**MARTIN LUTHER KING JR. RECREATION CENTER
ROOF REPLACEMENT**

Addendum No. 1

Dated: February 18, 2021

Project No.: 16366E-02-02

Work No.: **16366E-02-02** Drawing No.: **A-101**

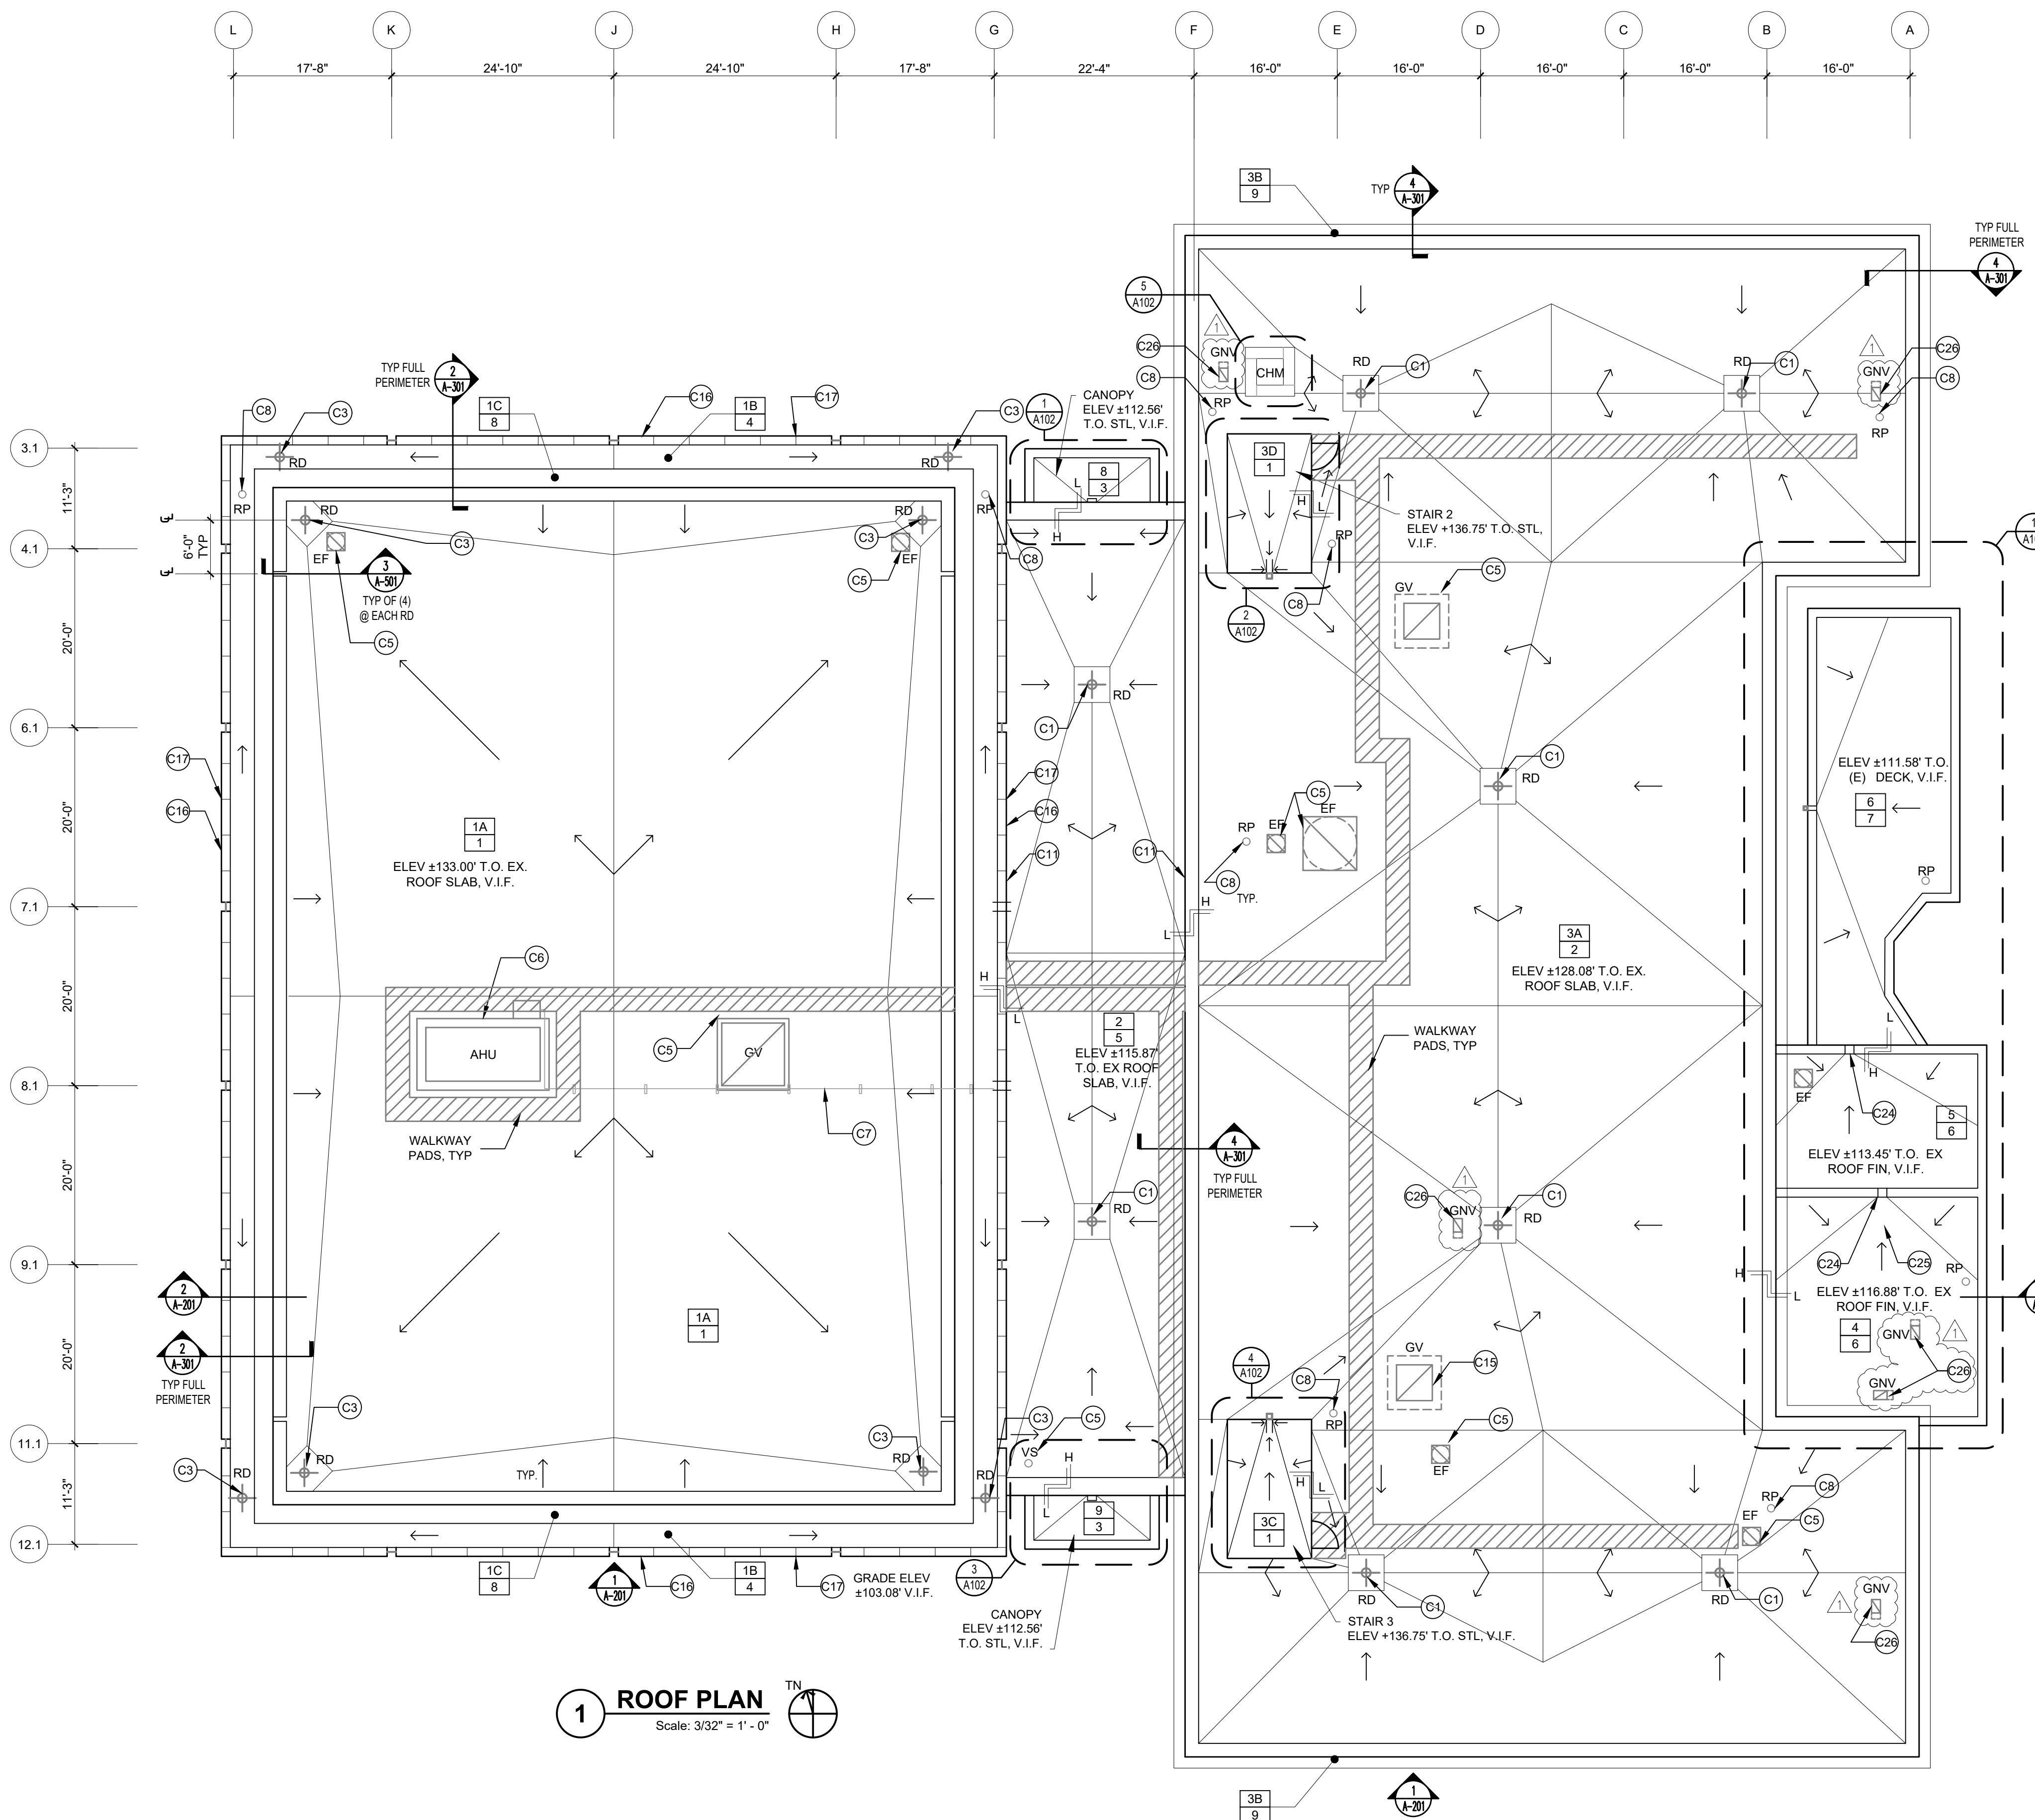
4. Drawing A-102:
 - a. Remove drawing A-102 from Attachment D – Project Drawings and replace with drawing A-102 that is included in this amendment.

Submission: **FINAL PRICING SET**
Engineering Manager: **TARA RASHEED**
Consultant: **CONVERSE WINKLER ARCHITECTURE**
Task No.: _____ Drawn By: **TN**
Date: **SEPT. 4, 2020** Checked By: **AB**
Work No.: **16366E-02-02** Drawing No.: **A-500.2**
CW-1909.02

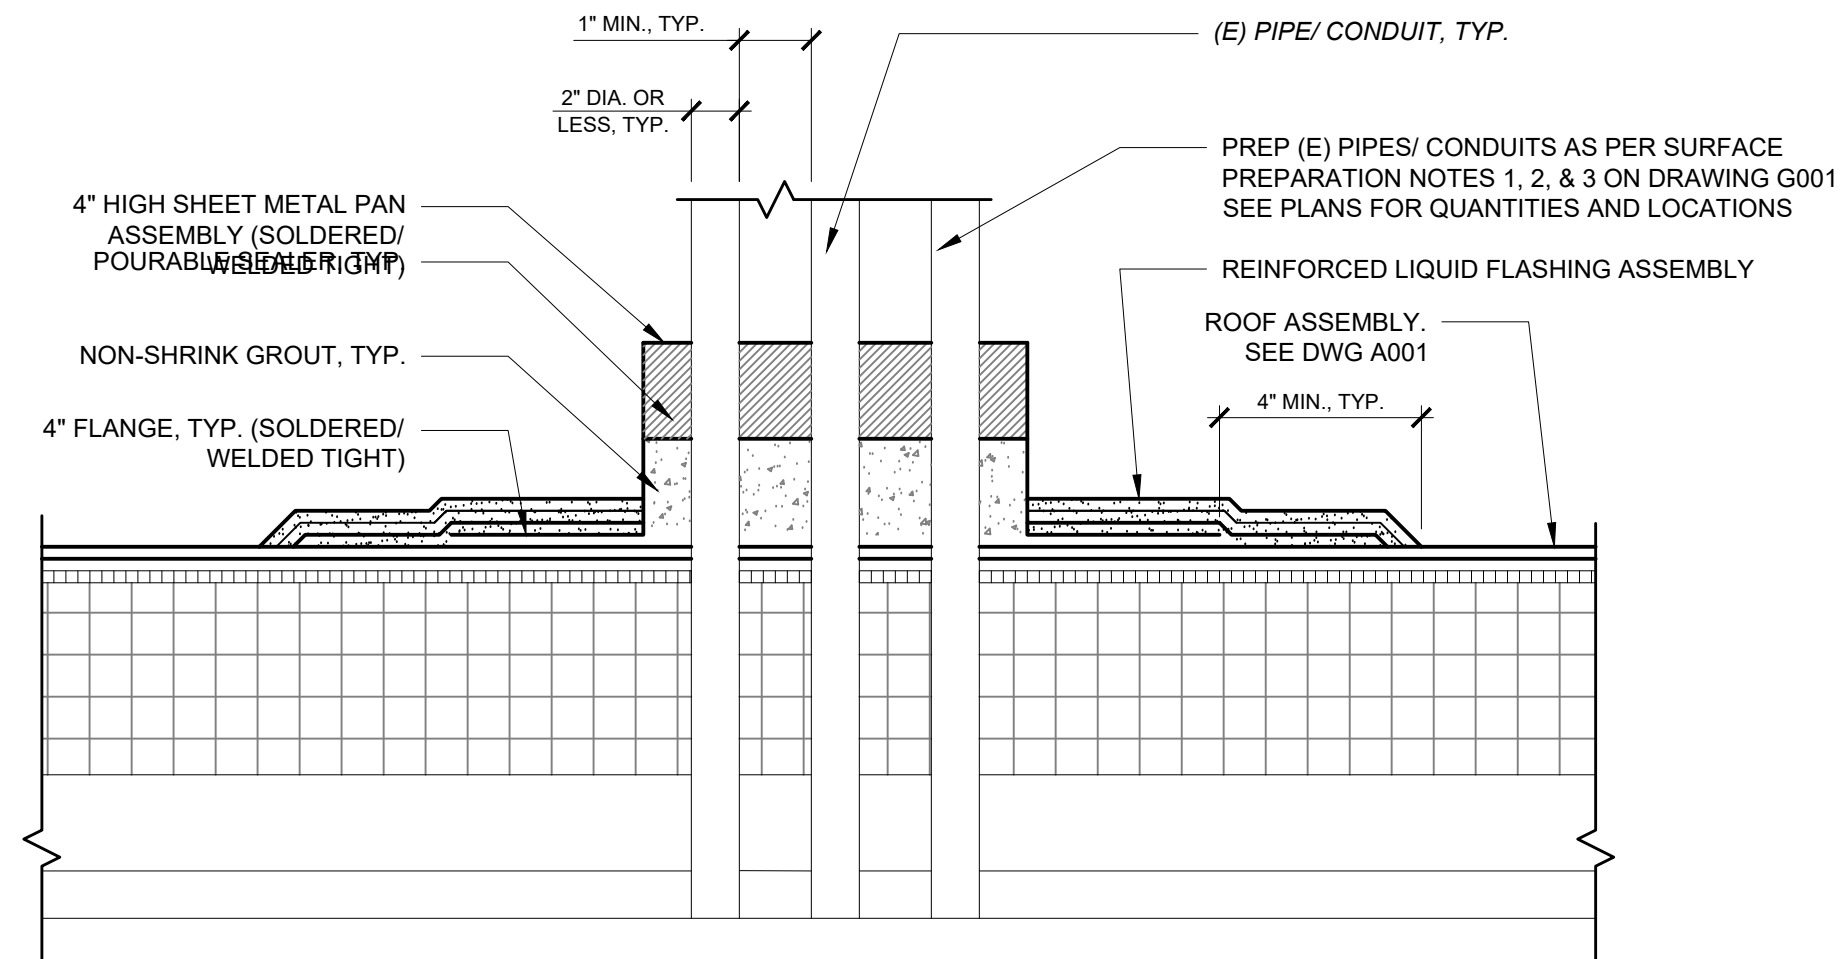
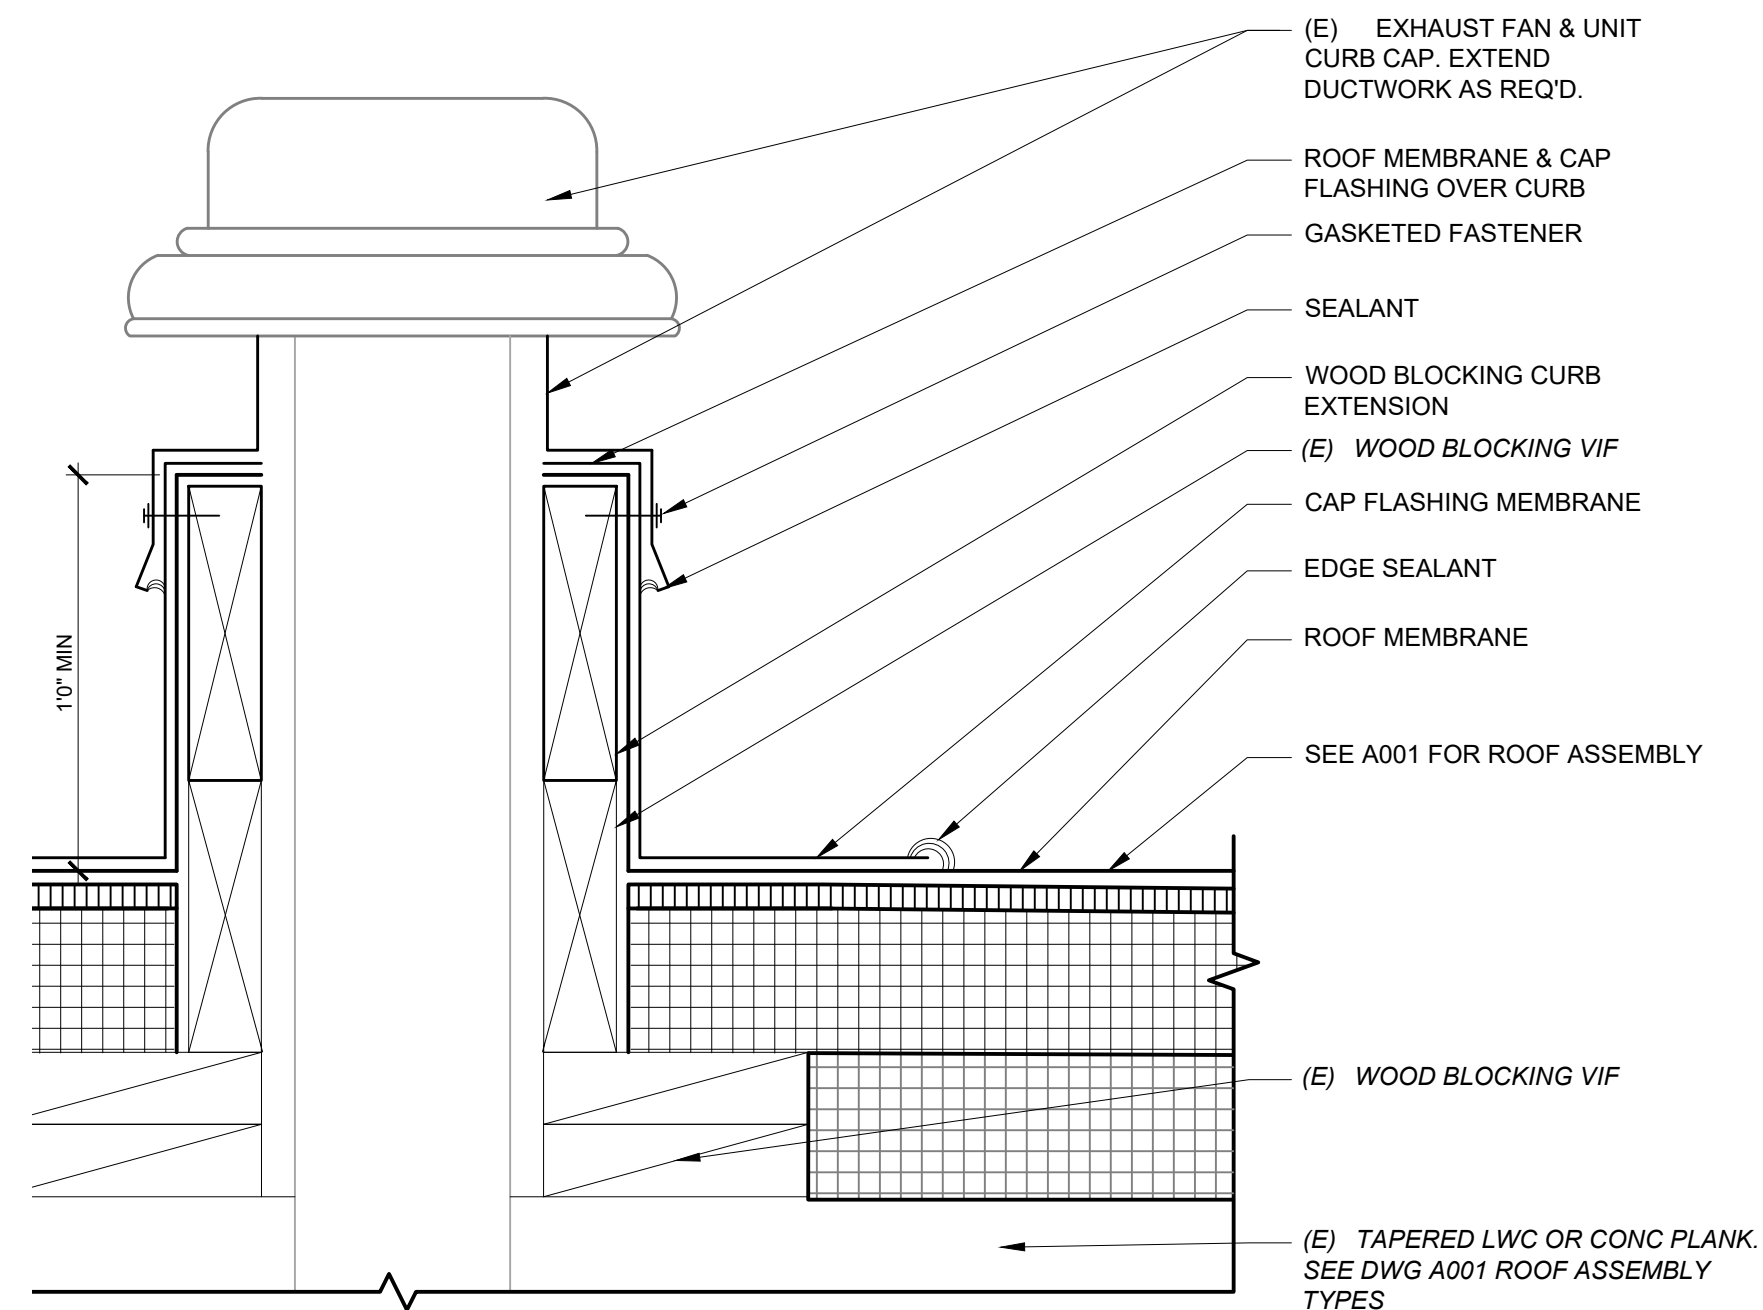
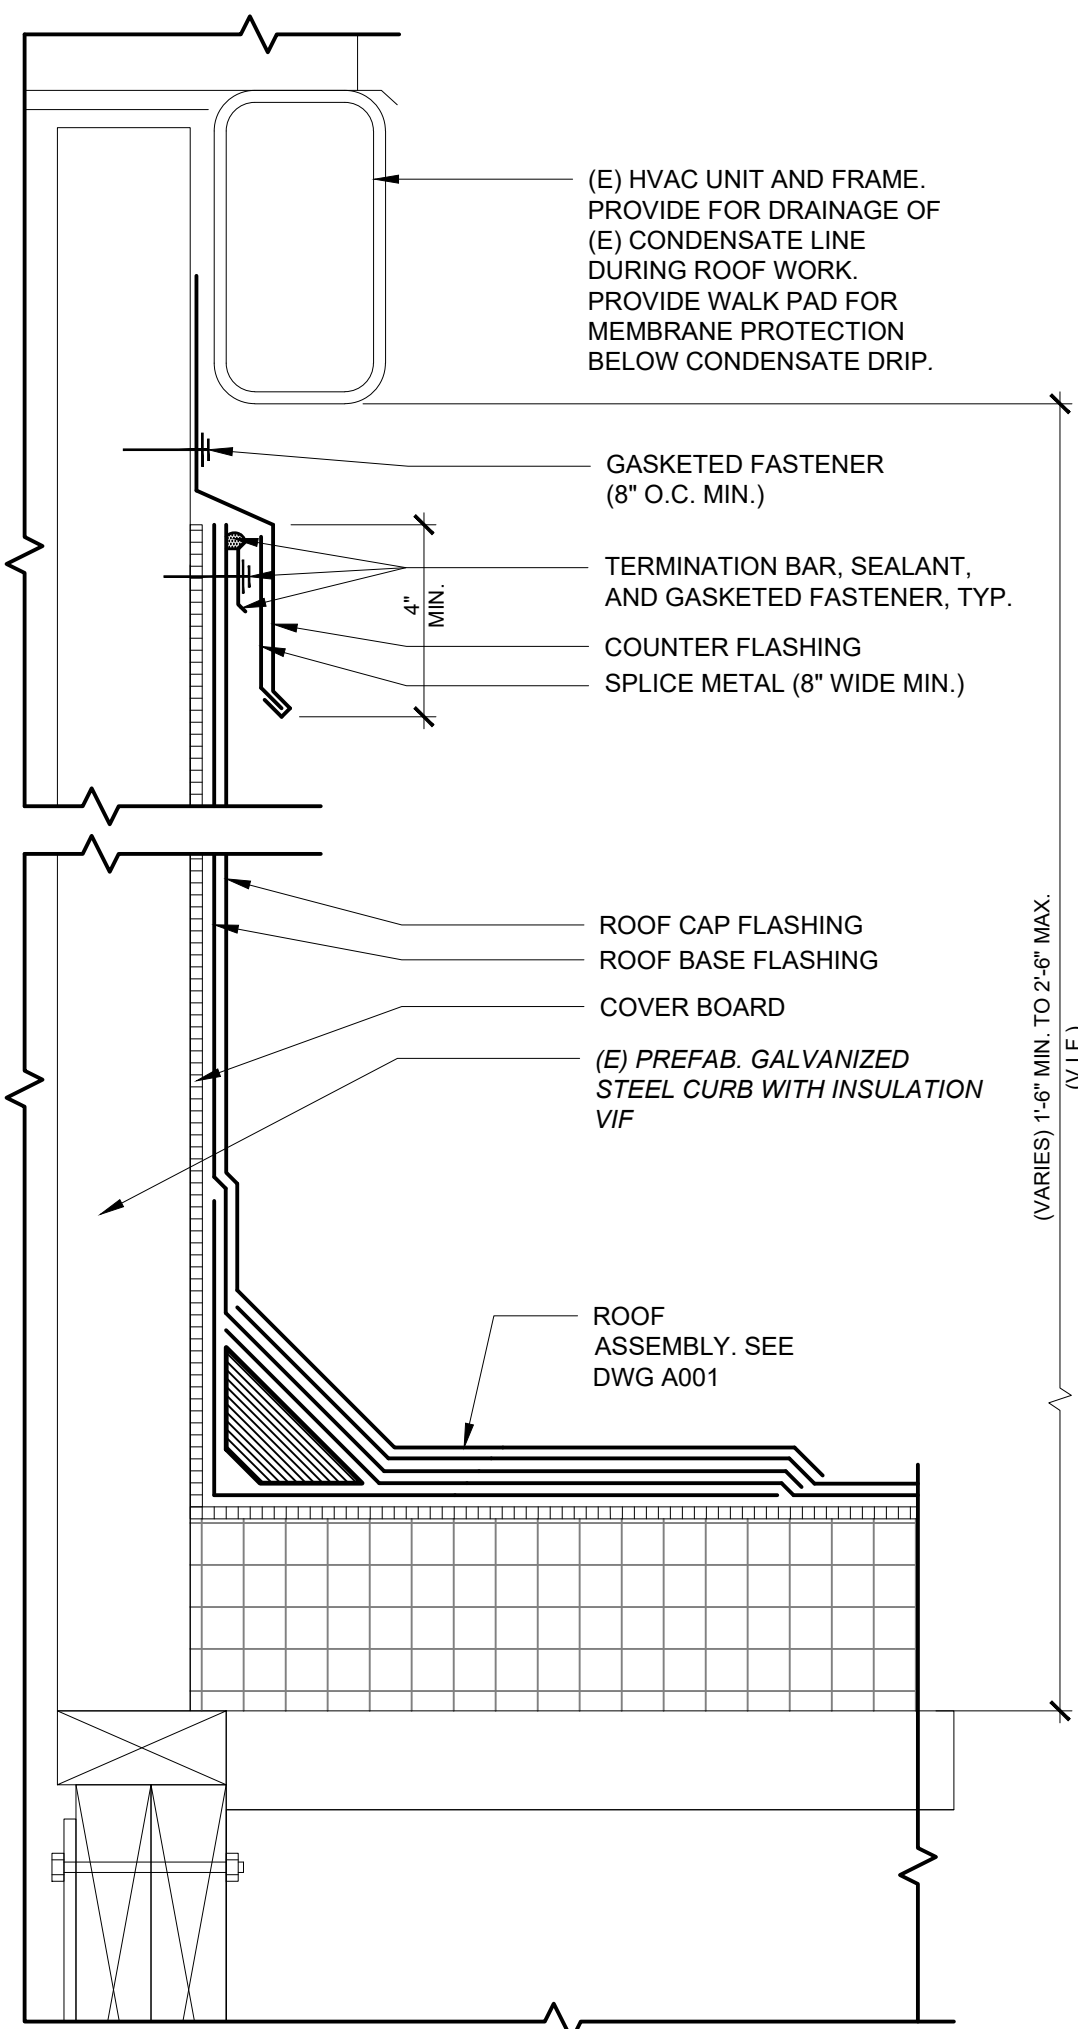
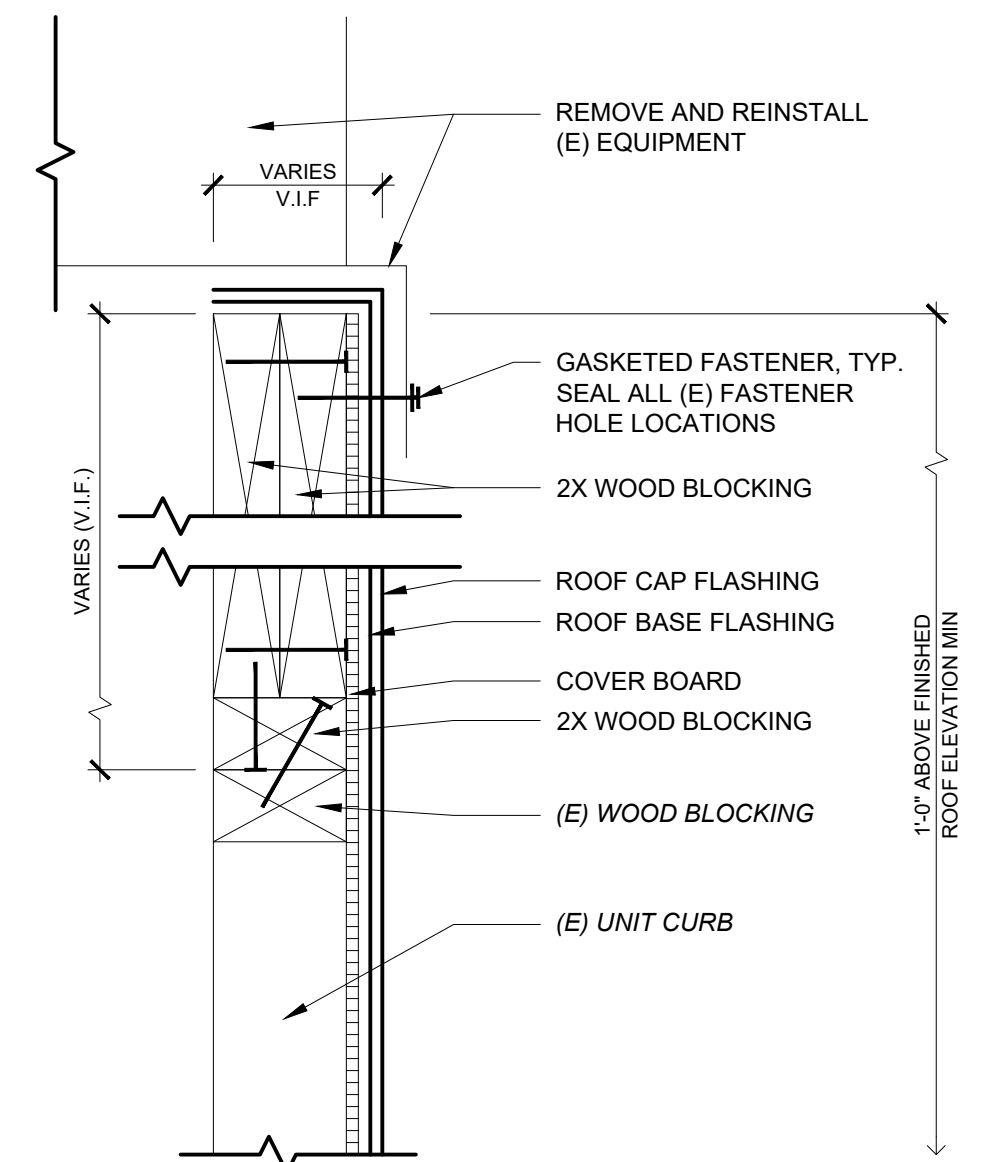
5. Drawing A-500.2:
 - a. Remove drawing A-500.2 from Attachment D – Project Drawings and replace with drawing A-102 that is included in this amendment.
